LONG BRANCH CORNER
PRELIMINARY PLAN

RE: Preliminary Plan No. 120180090
Long Branch Corner

We have completed our review of the preliminary plan uploaded to eplans on October 1, 2020 and reviewed by the Development Review Committee at its September 1, 2020 meeting. We recommend approval of the plan subject to the following comments:

ATTACHMENT (a): MTA

PP2.01

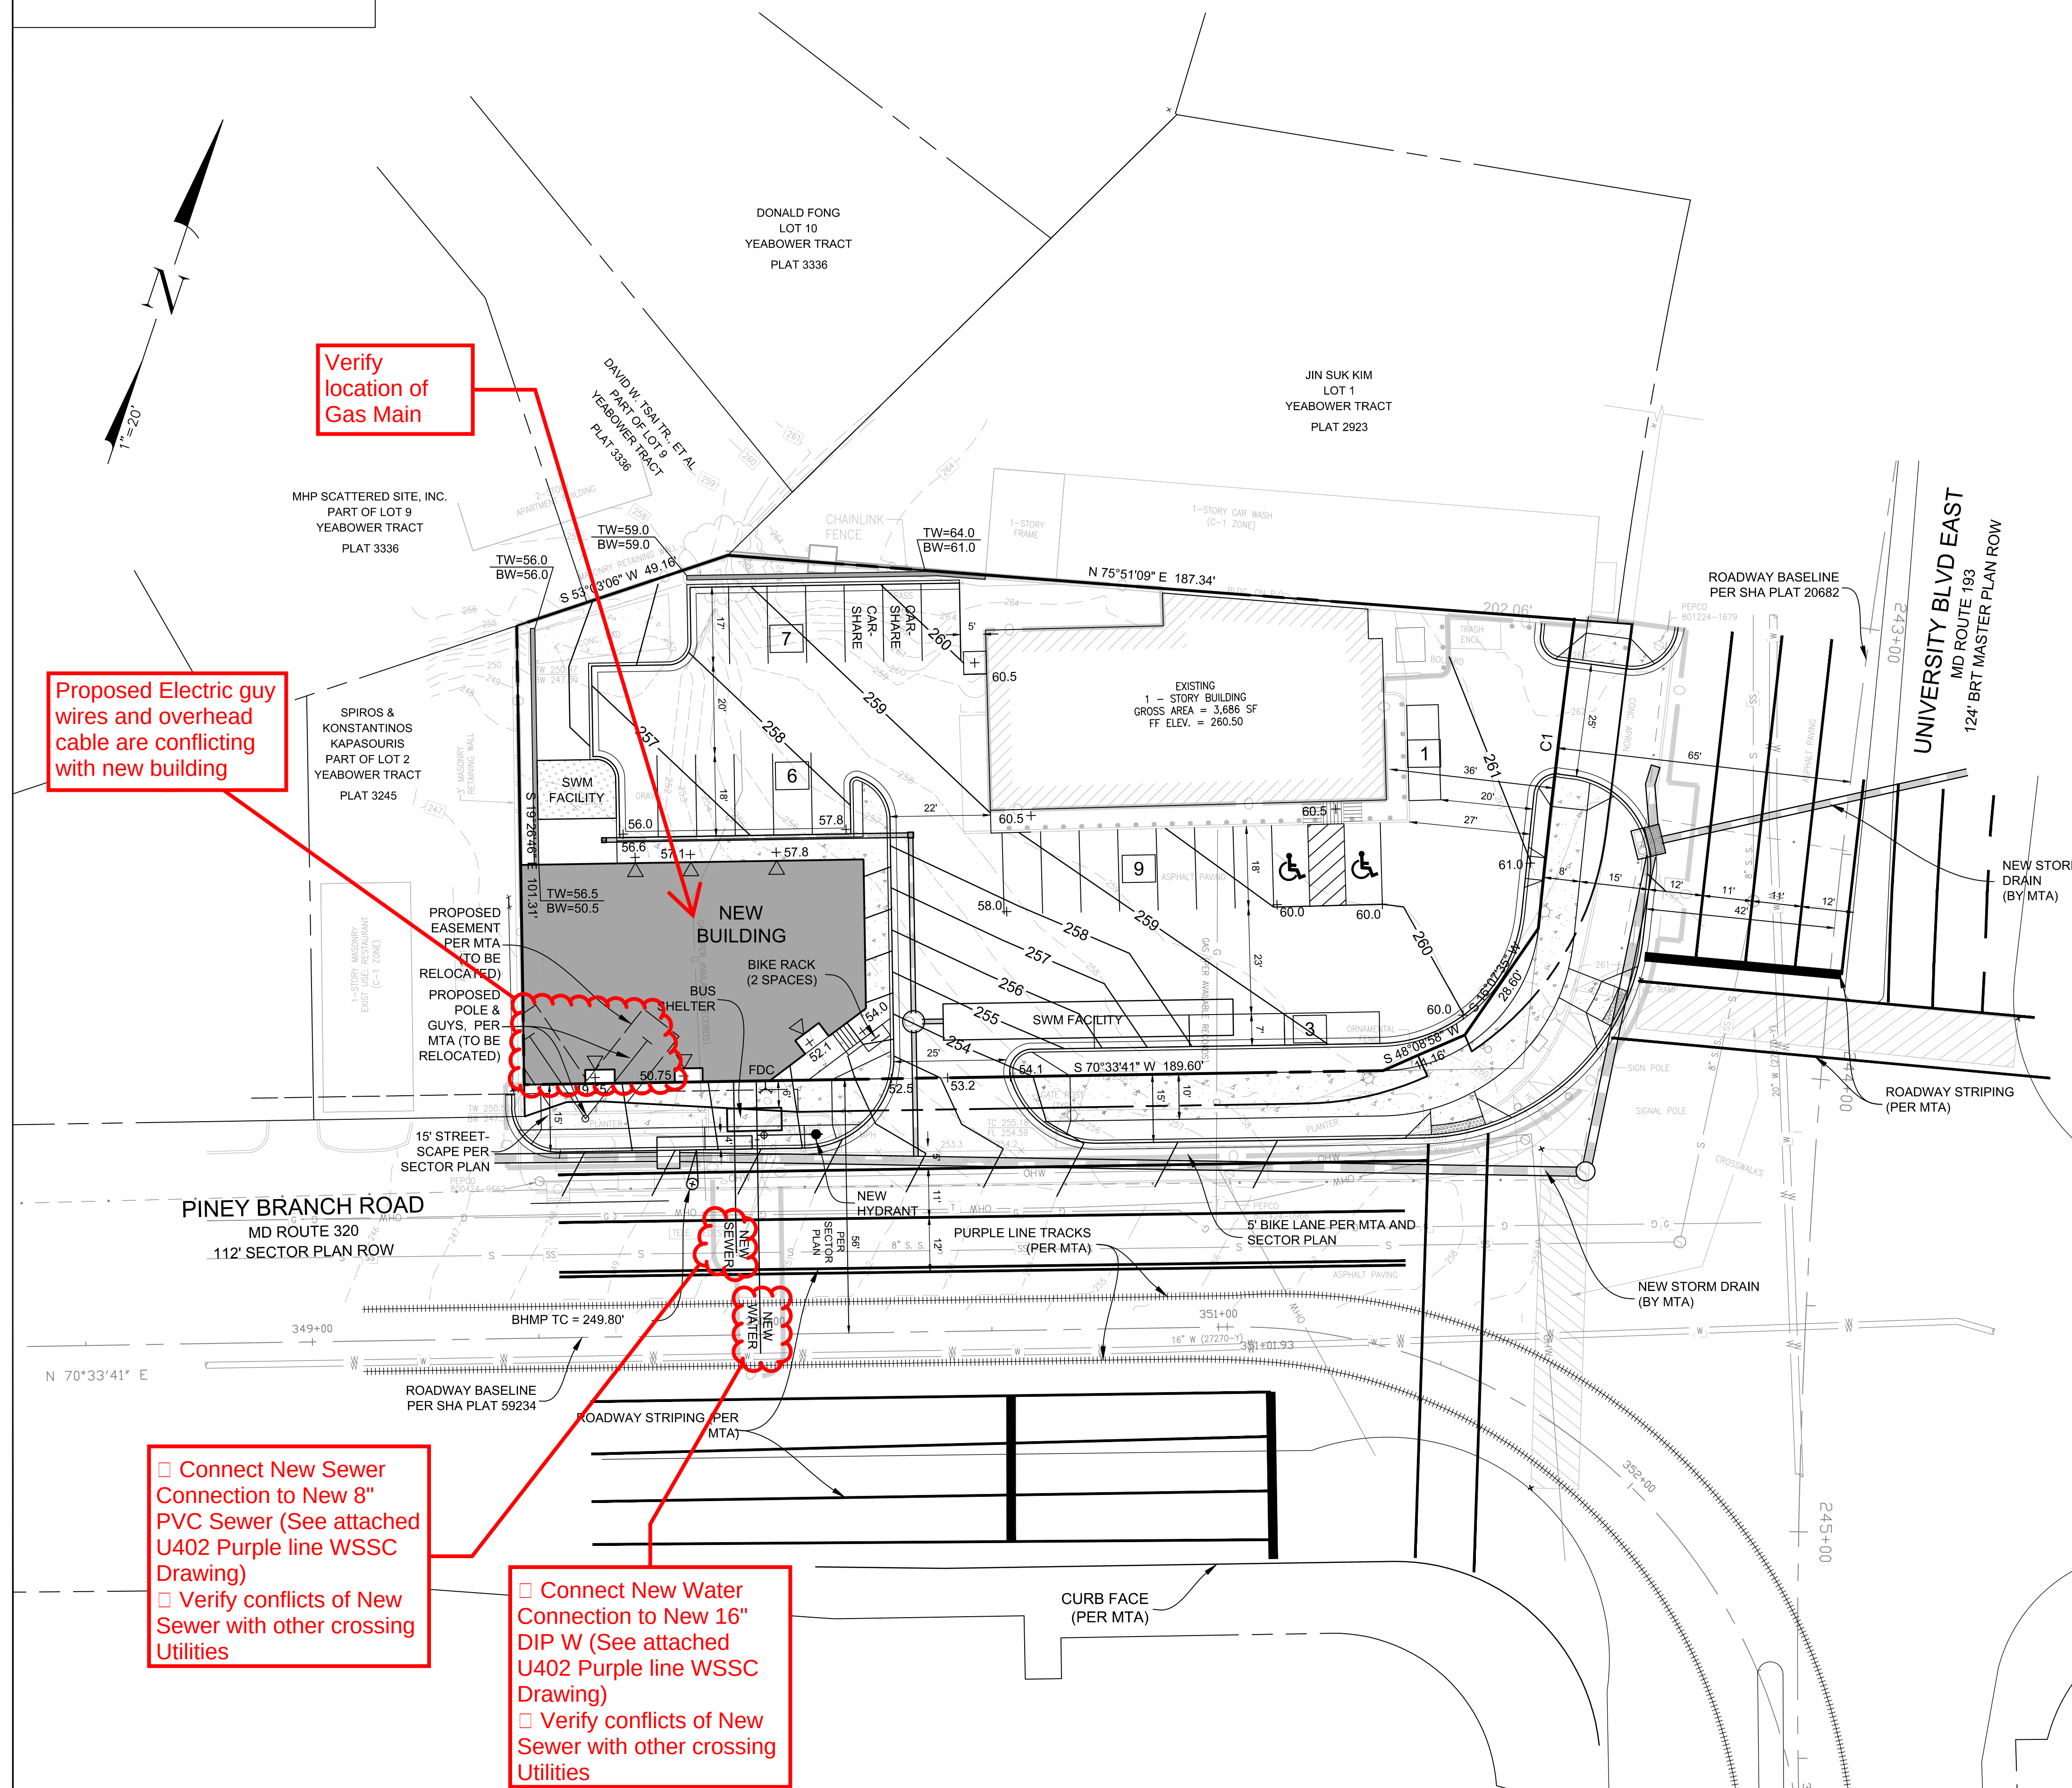
1. Please see attached plan sheet (refer to attachment below) for comments from Maryland Transit Authority (MTA) regarding the purple line project. We recommend that the applicant coordinate with Ms. Maricela Cordova, the Purple Line Implementation Manager for Montgomery County at maricela.cordova@montgomerycountymd.gov and Mr. Steven Kolarz of the Purple Line project at steven.kolarz@purplelinemd.com.

Comments 10-9-2020

FIRE APPARATUS ACCESS PLAN

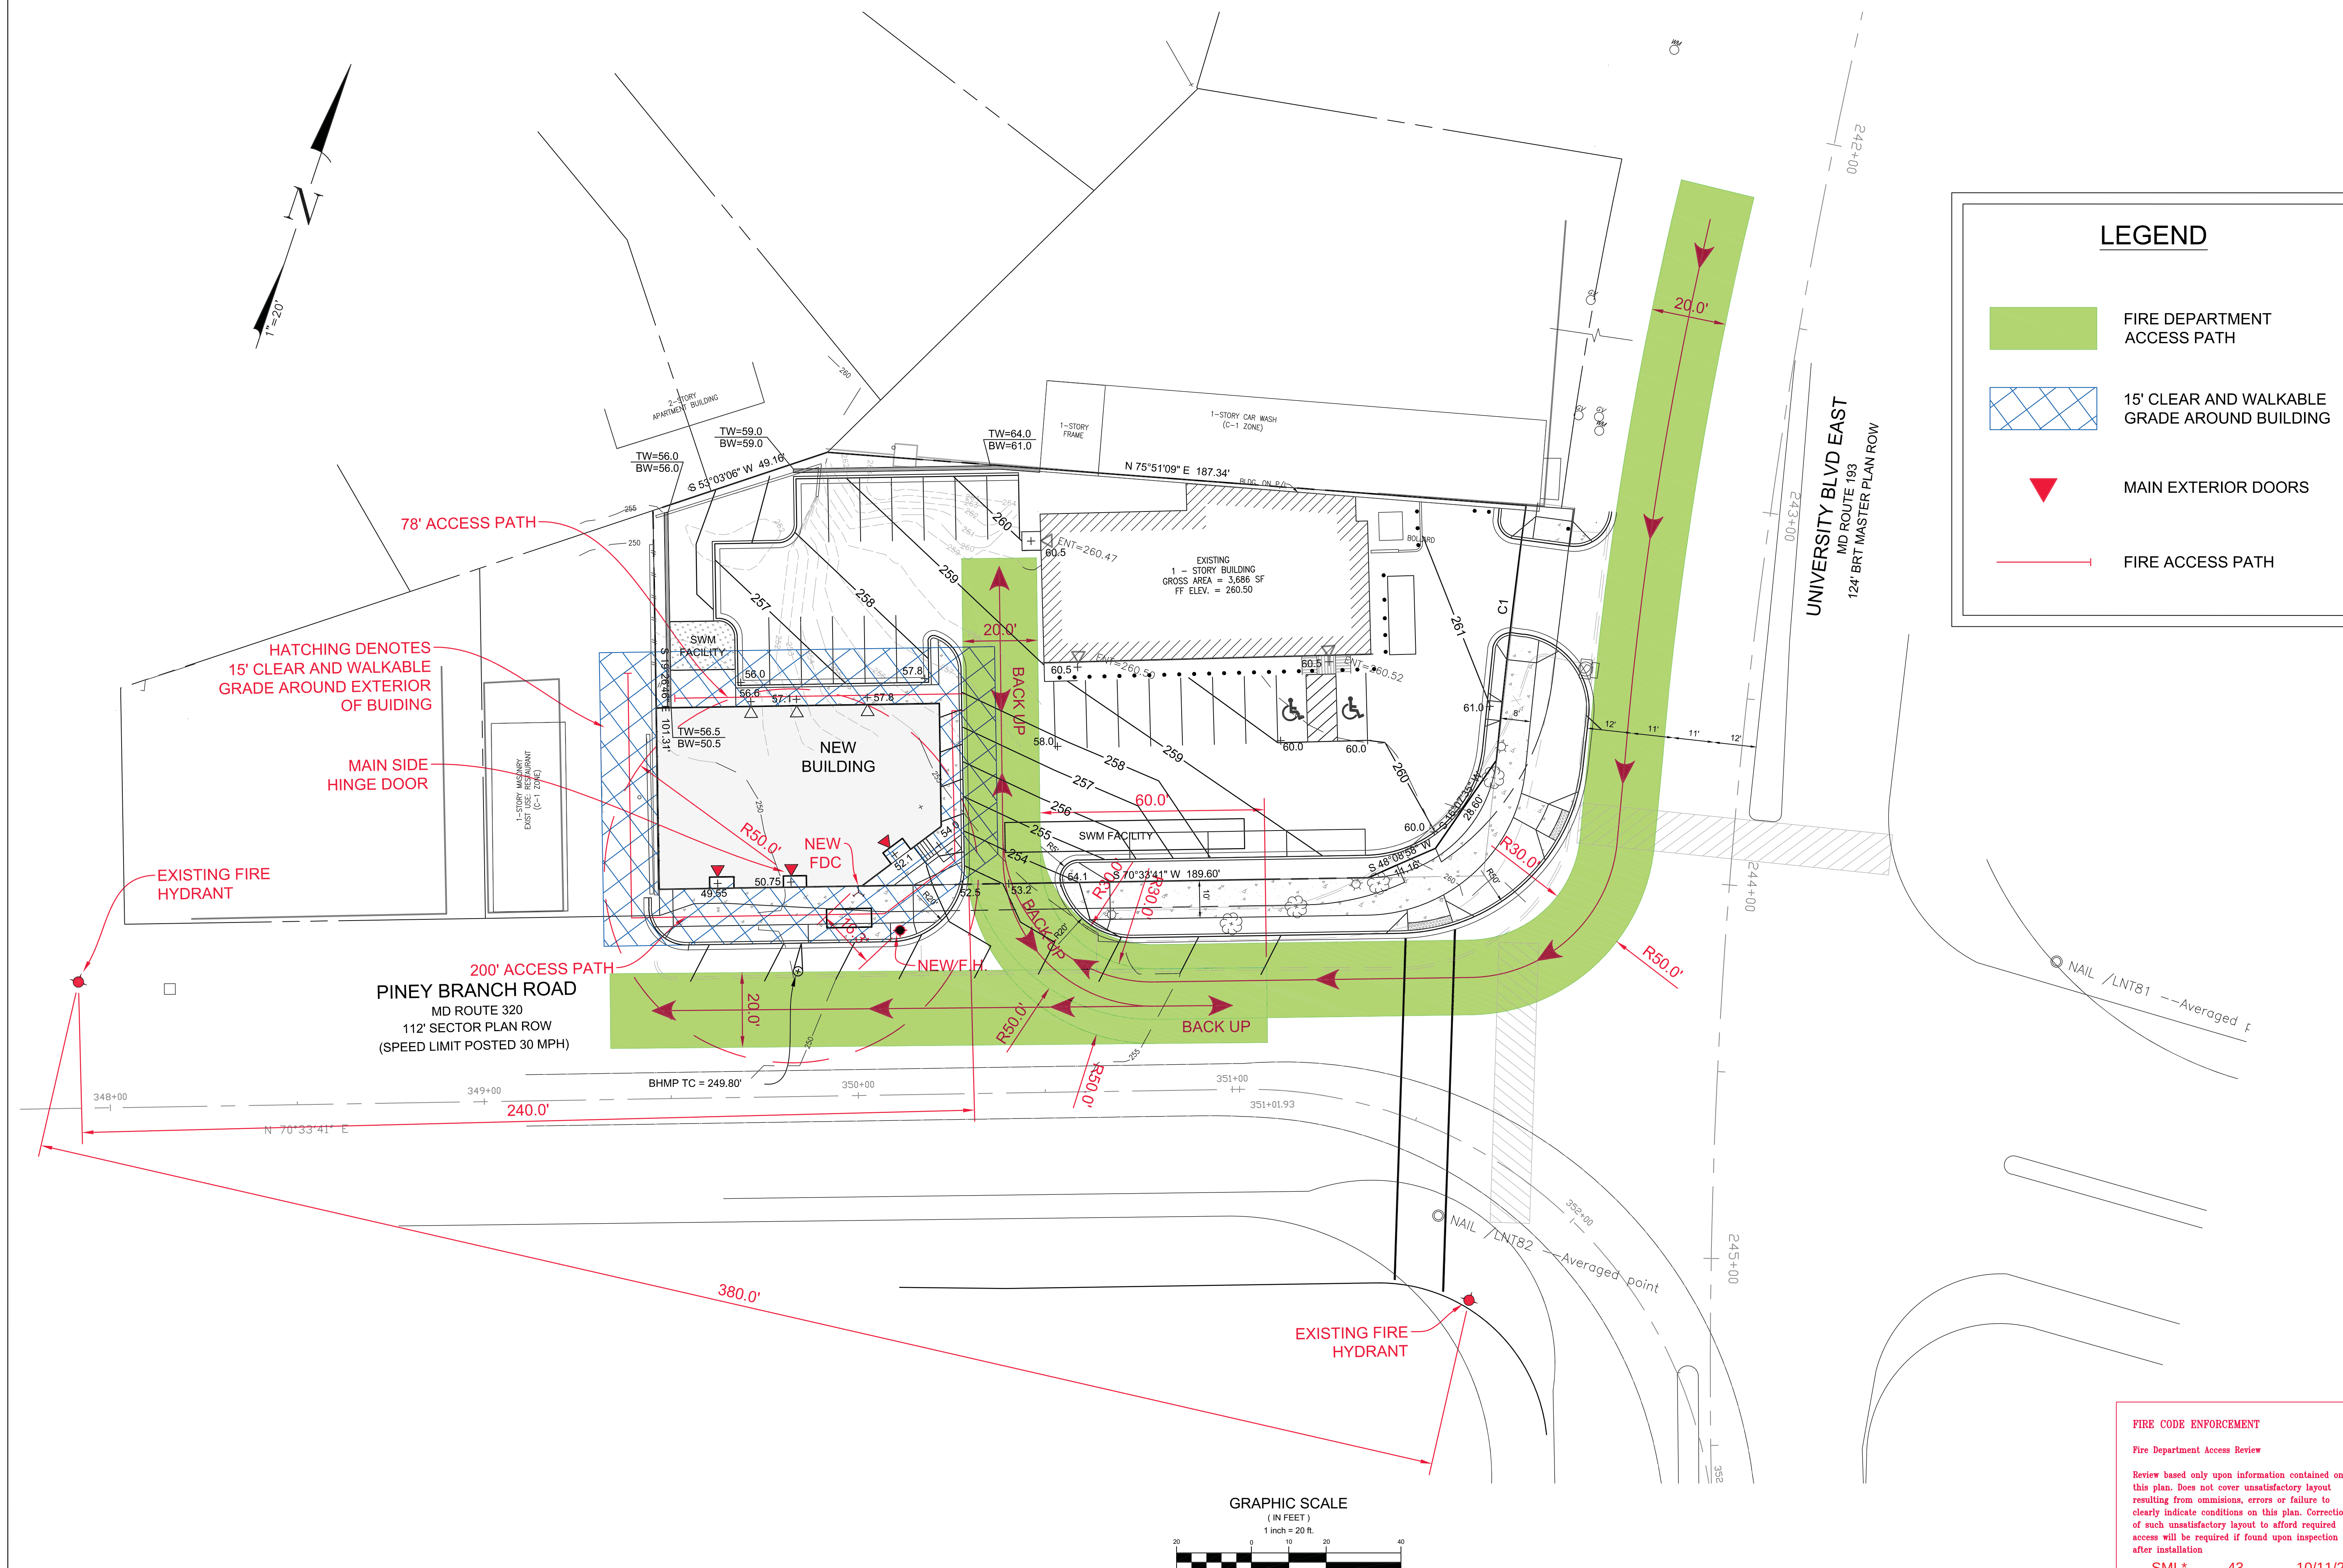
Fire Department Access Review

Review based only upon information contained on this plan. Does not cover unsatisfactory layout resulting from omissions, errors or failure to clearly indicate conditions on this plan. Correction of such unsatisfactory layout to afford required access will be required if found upon inspection after installation
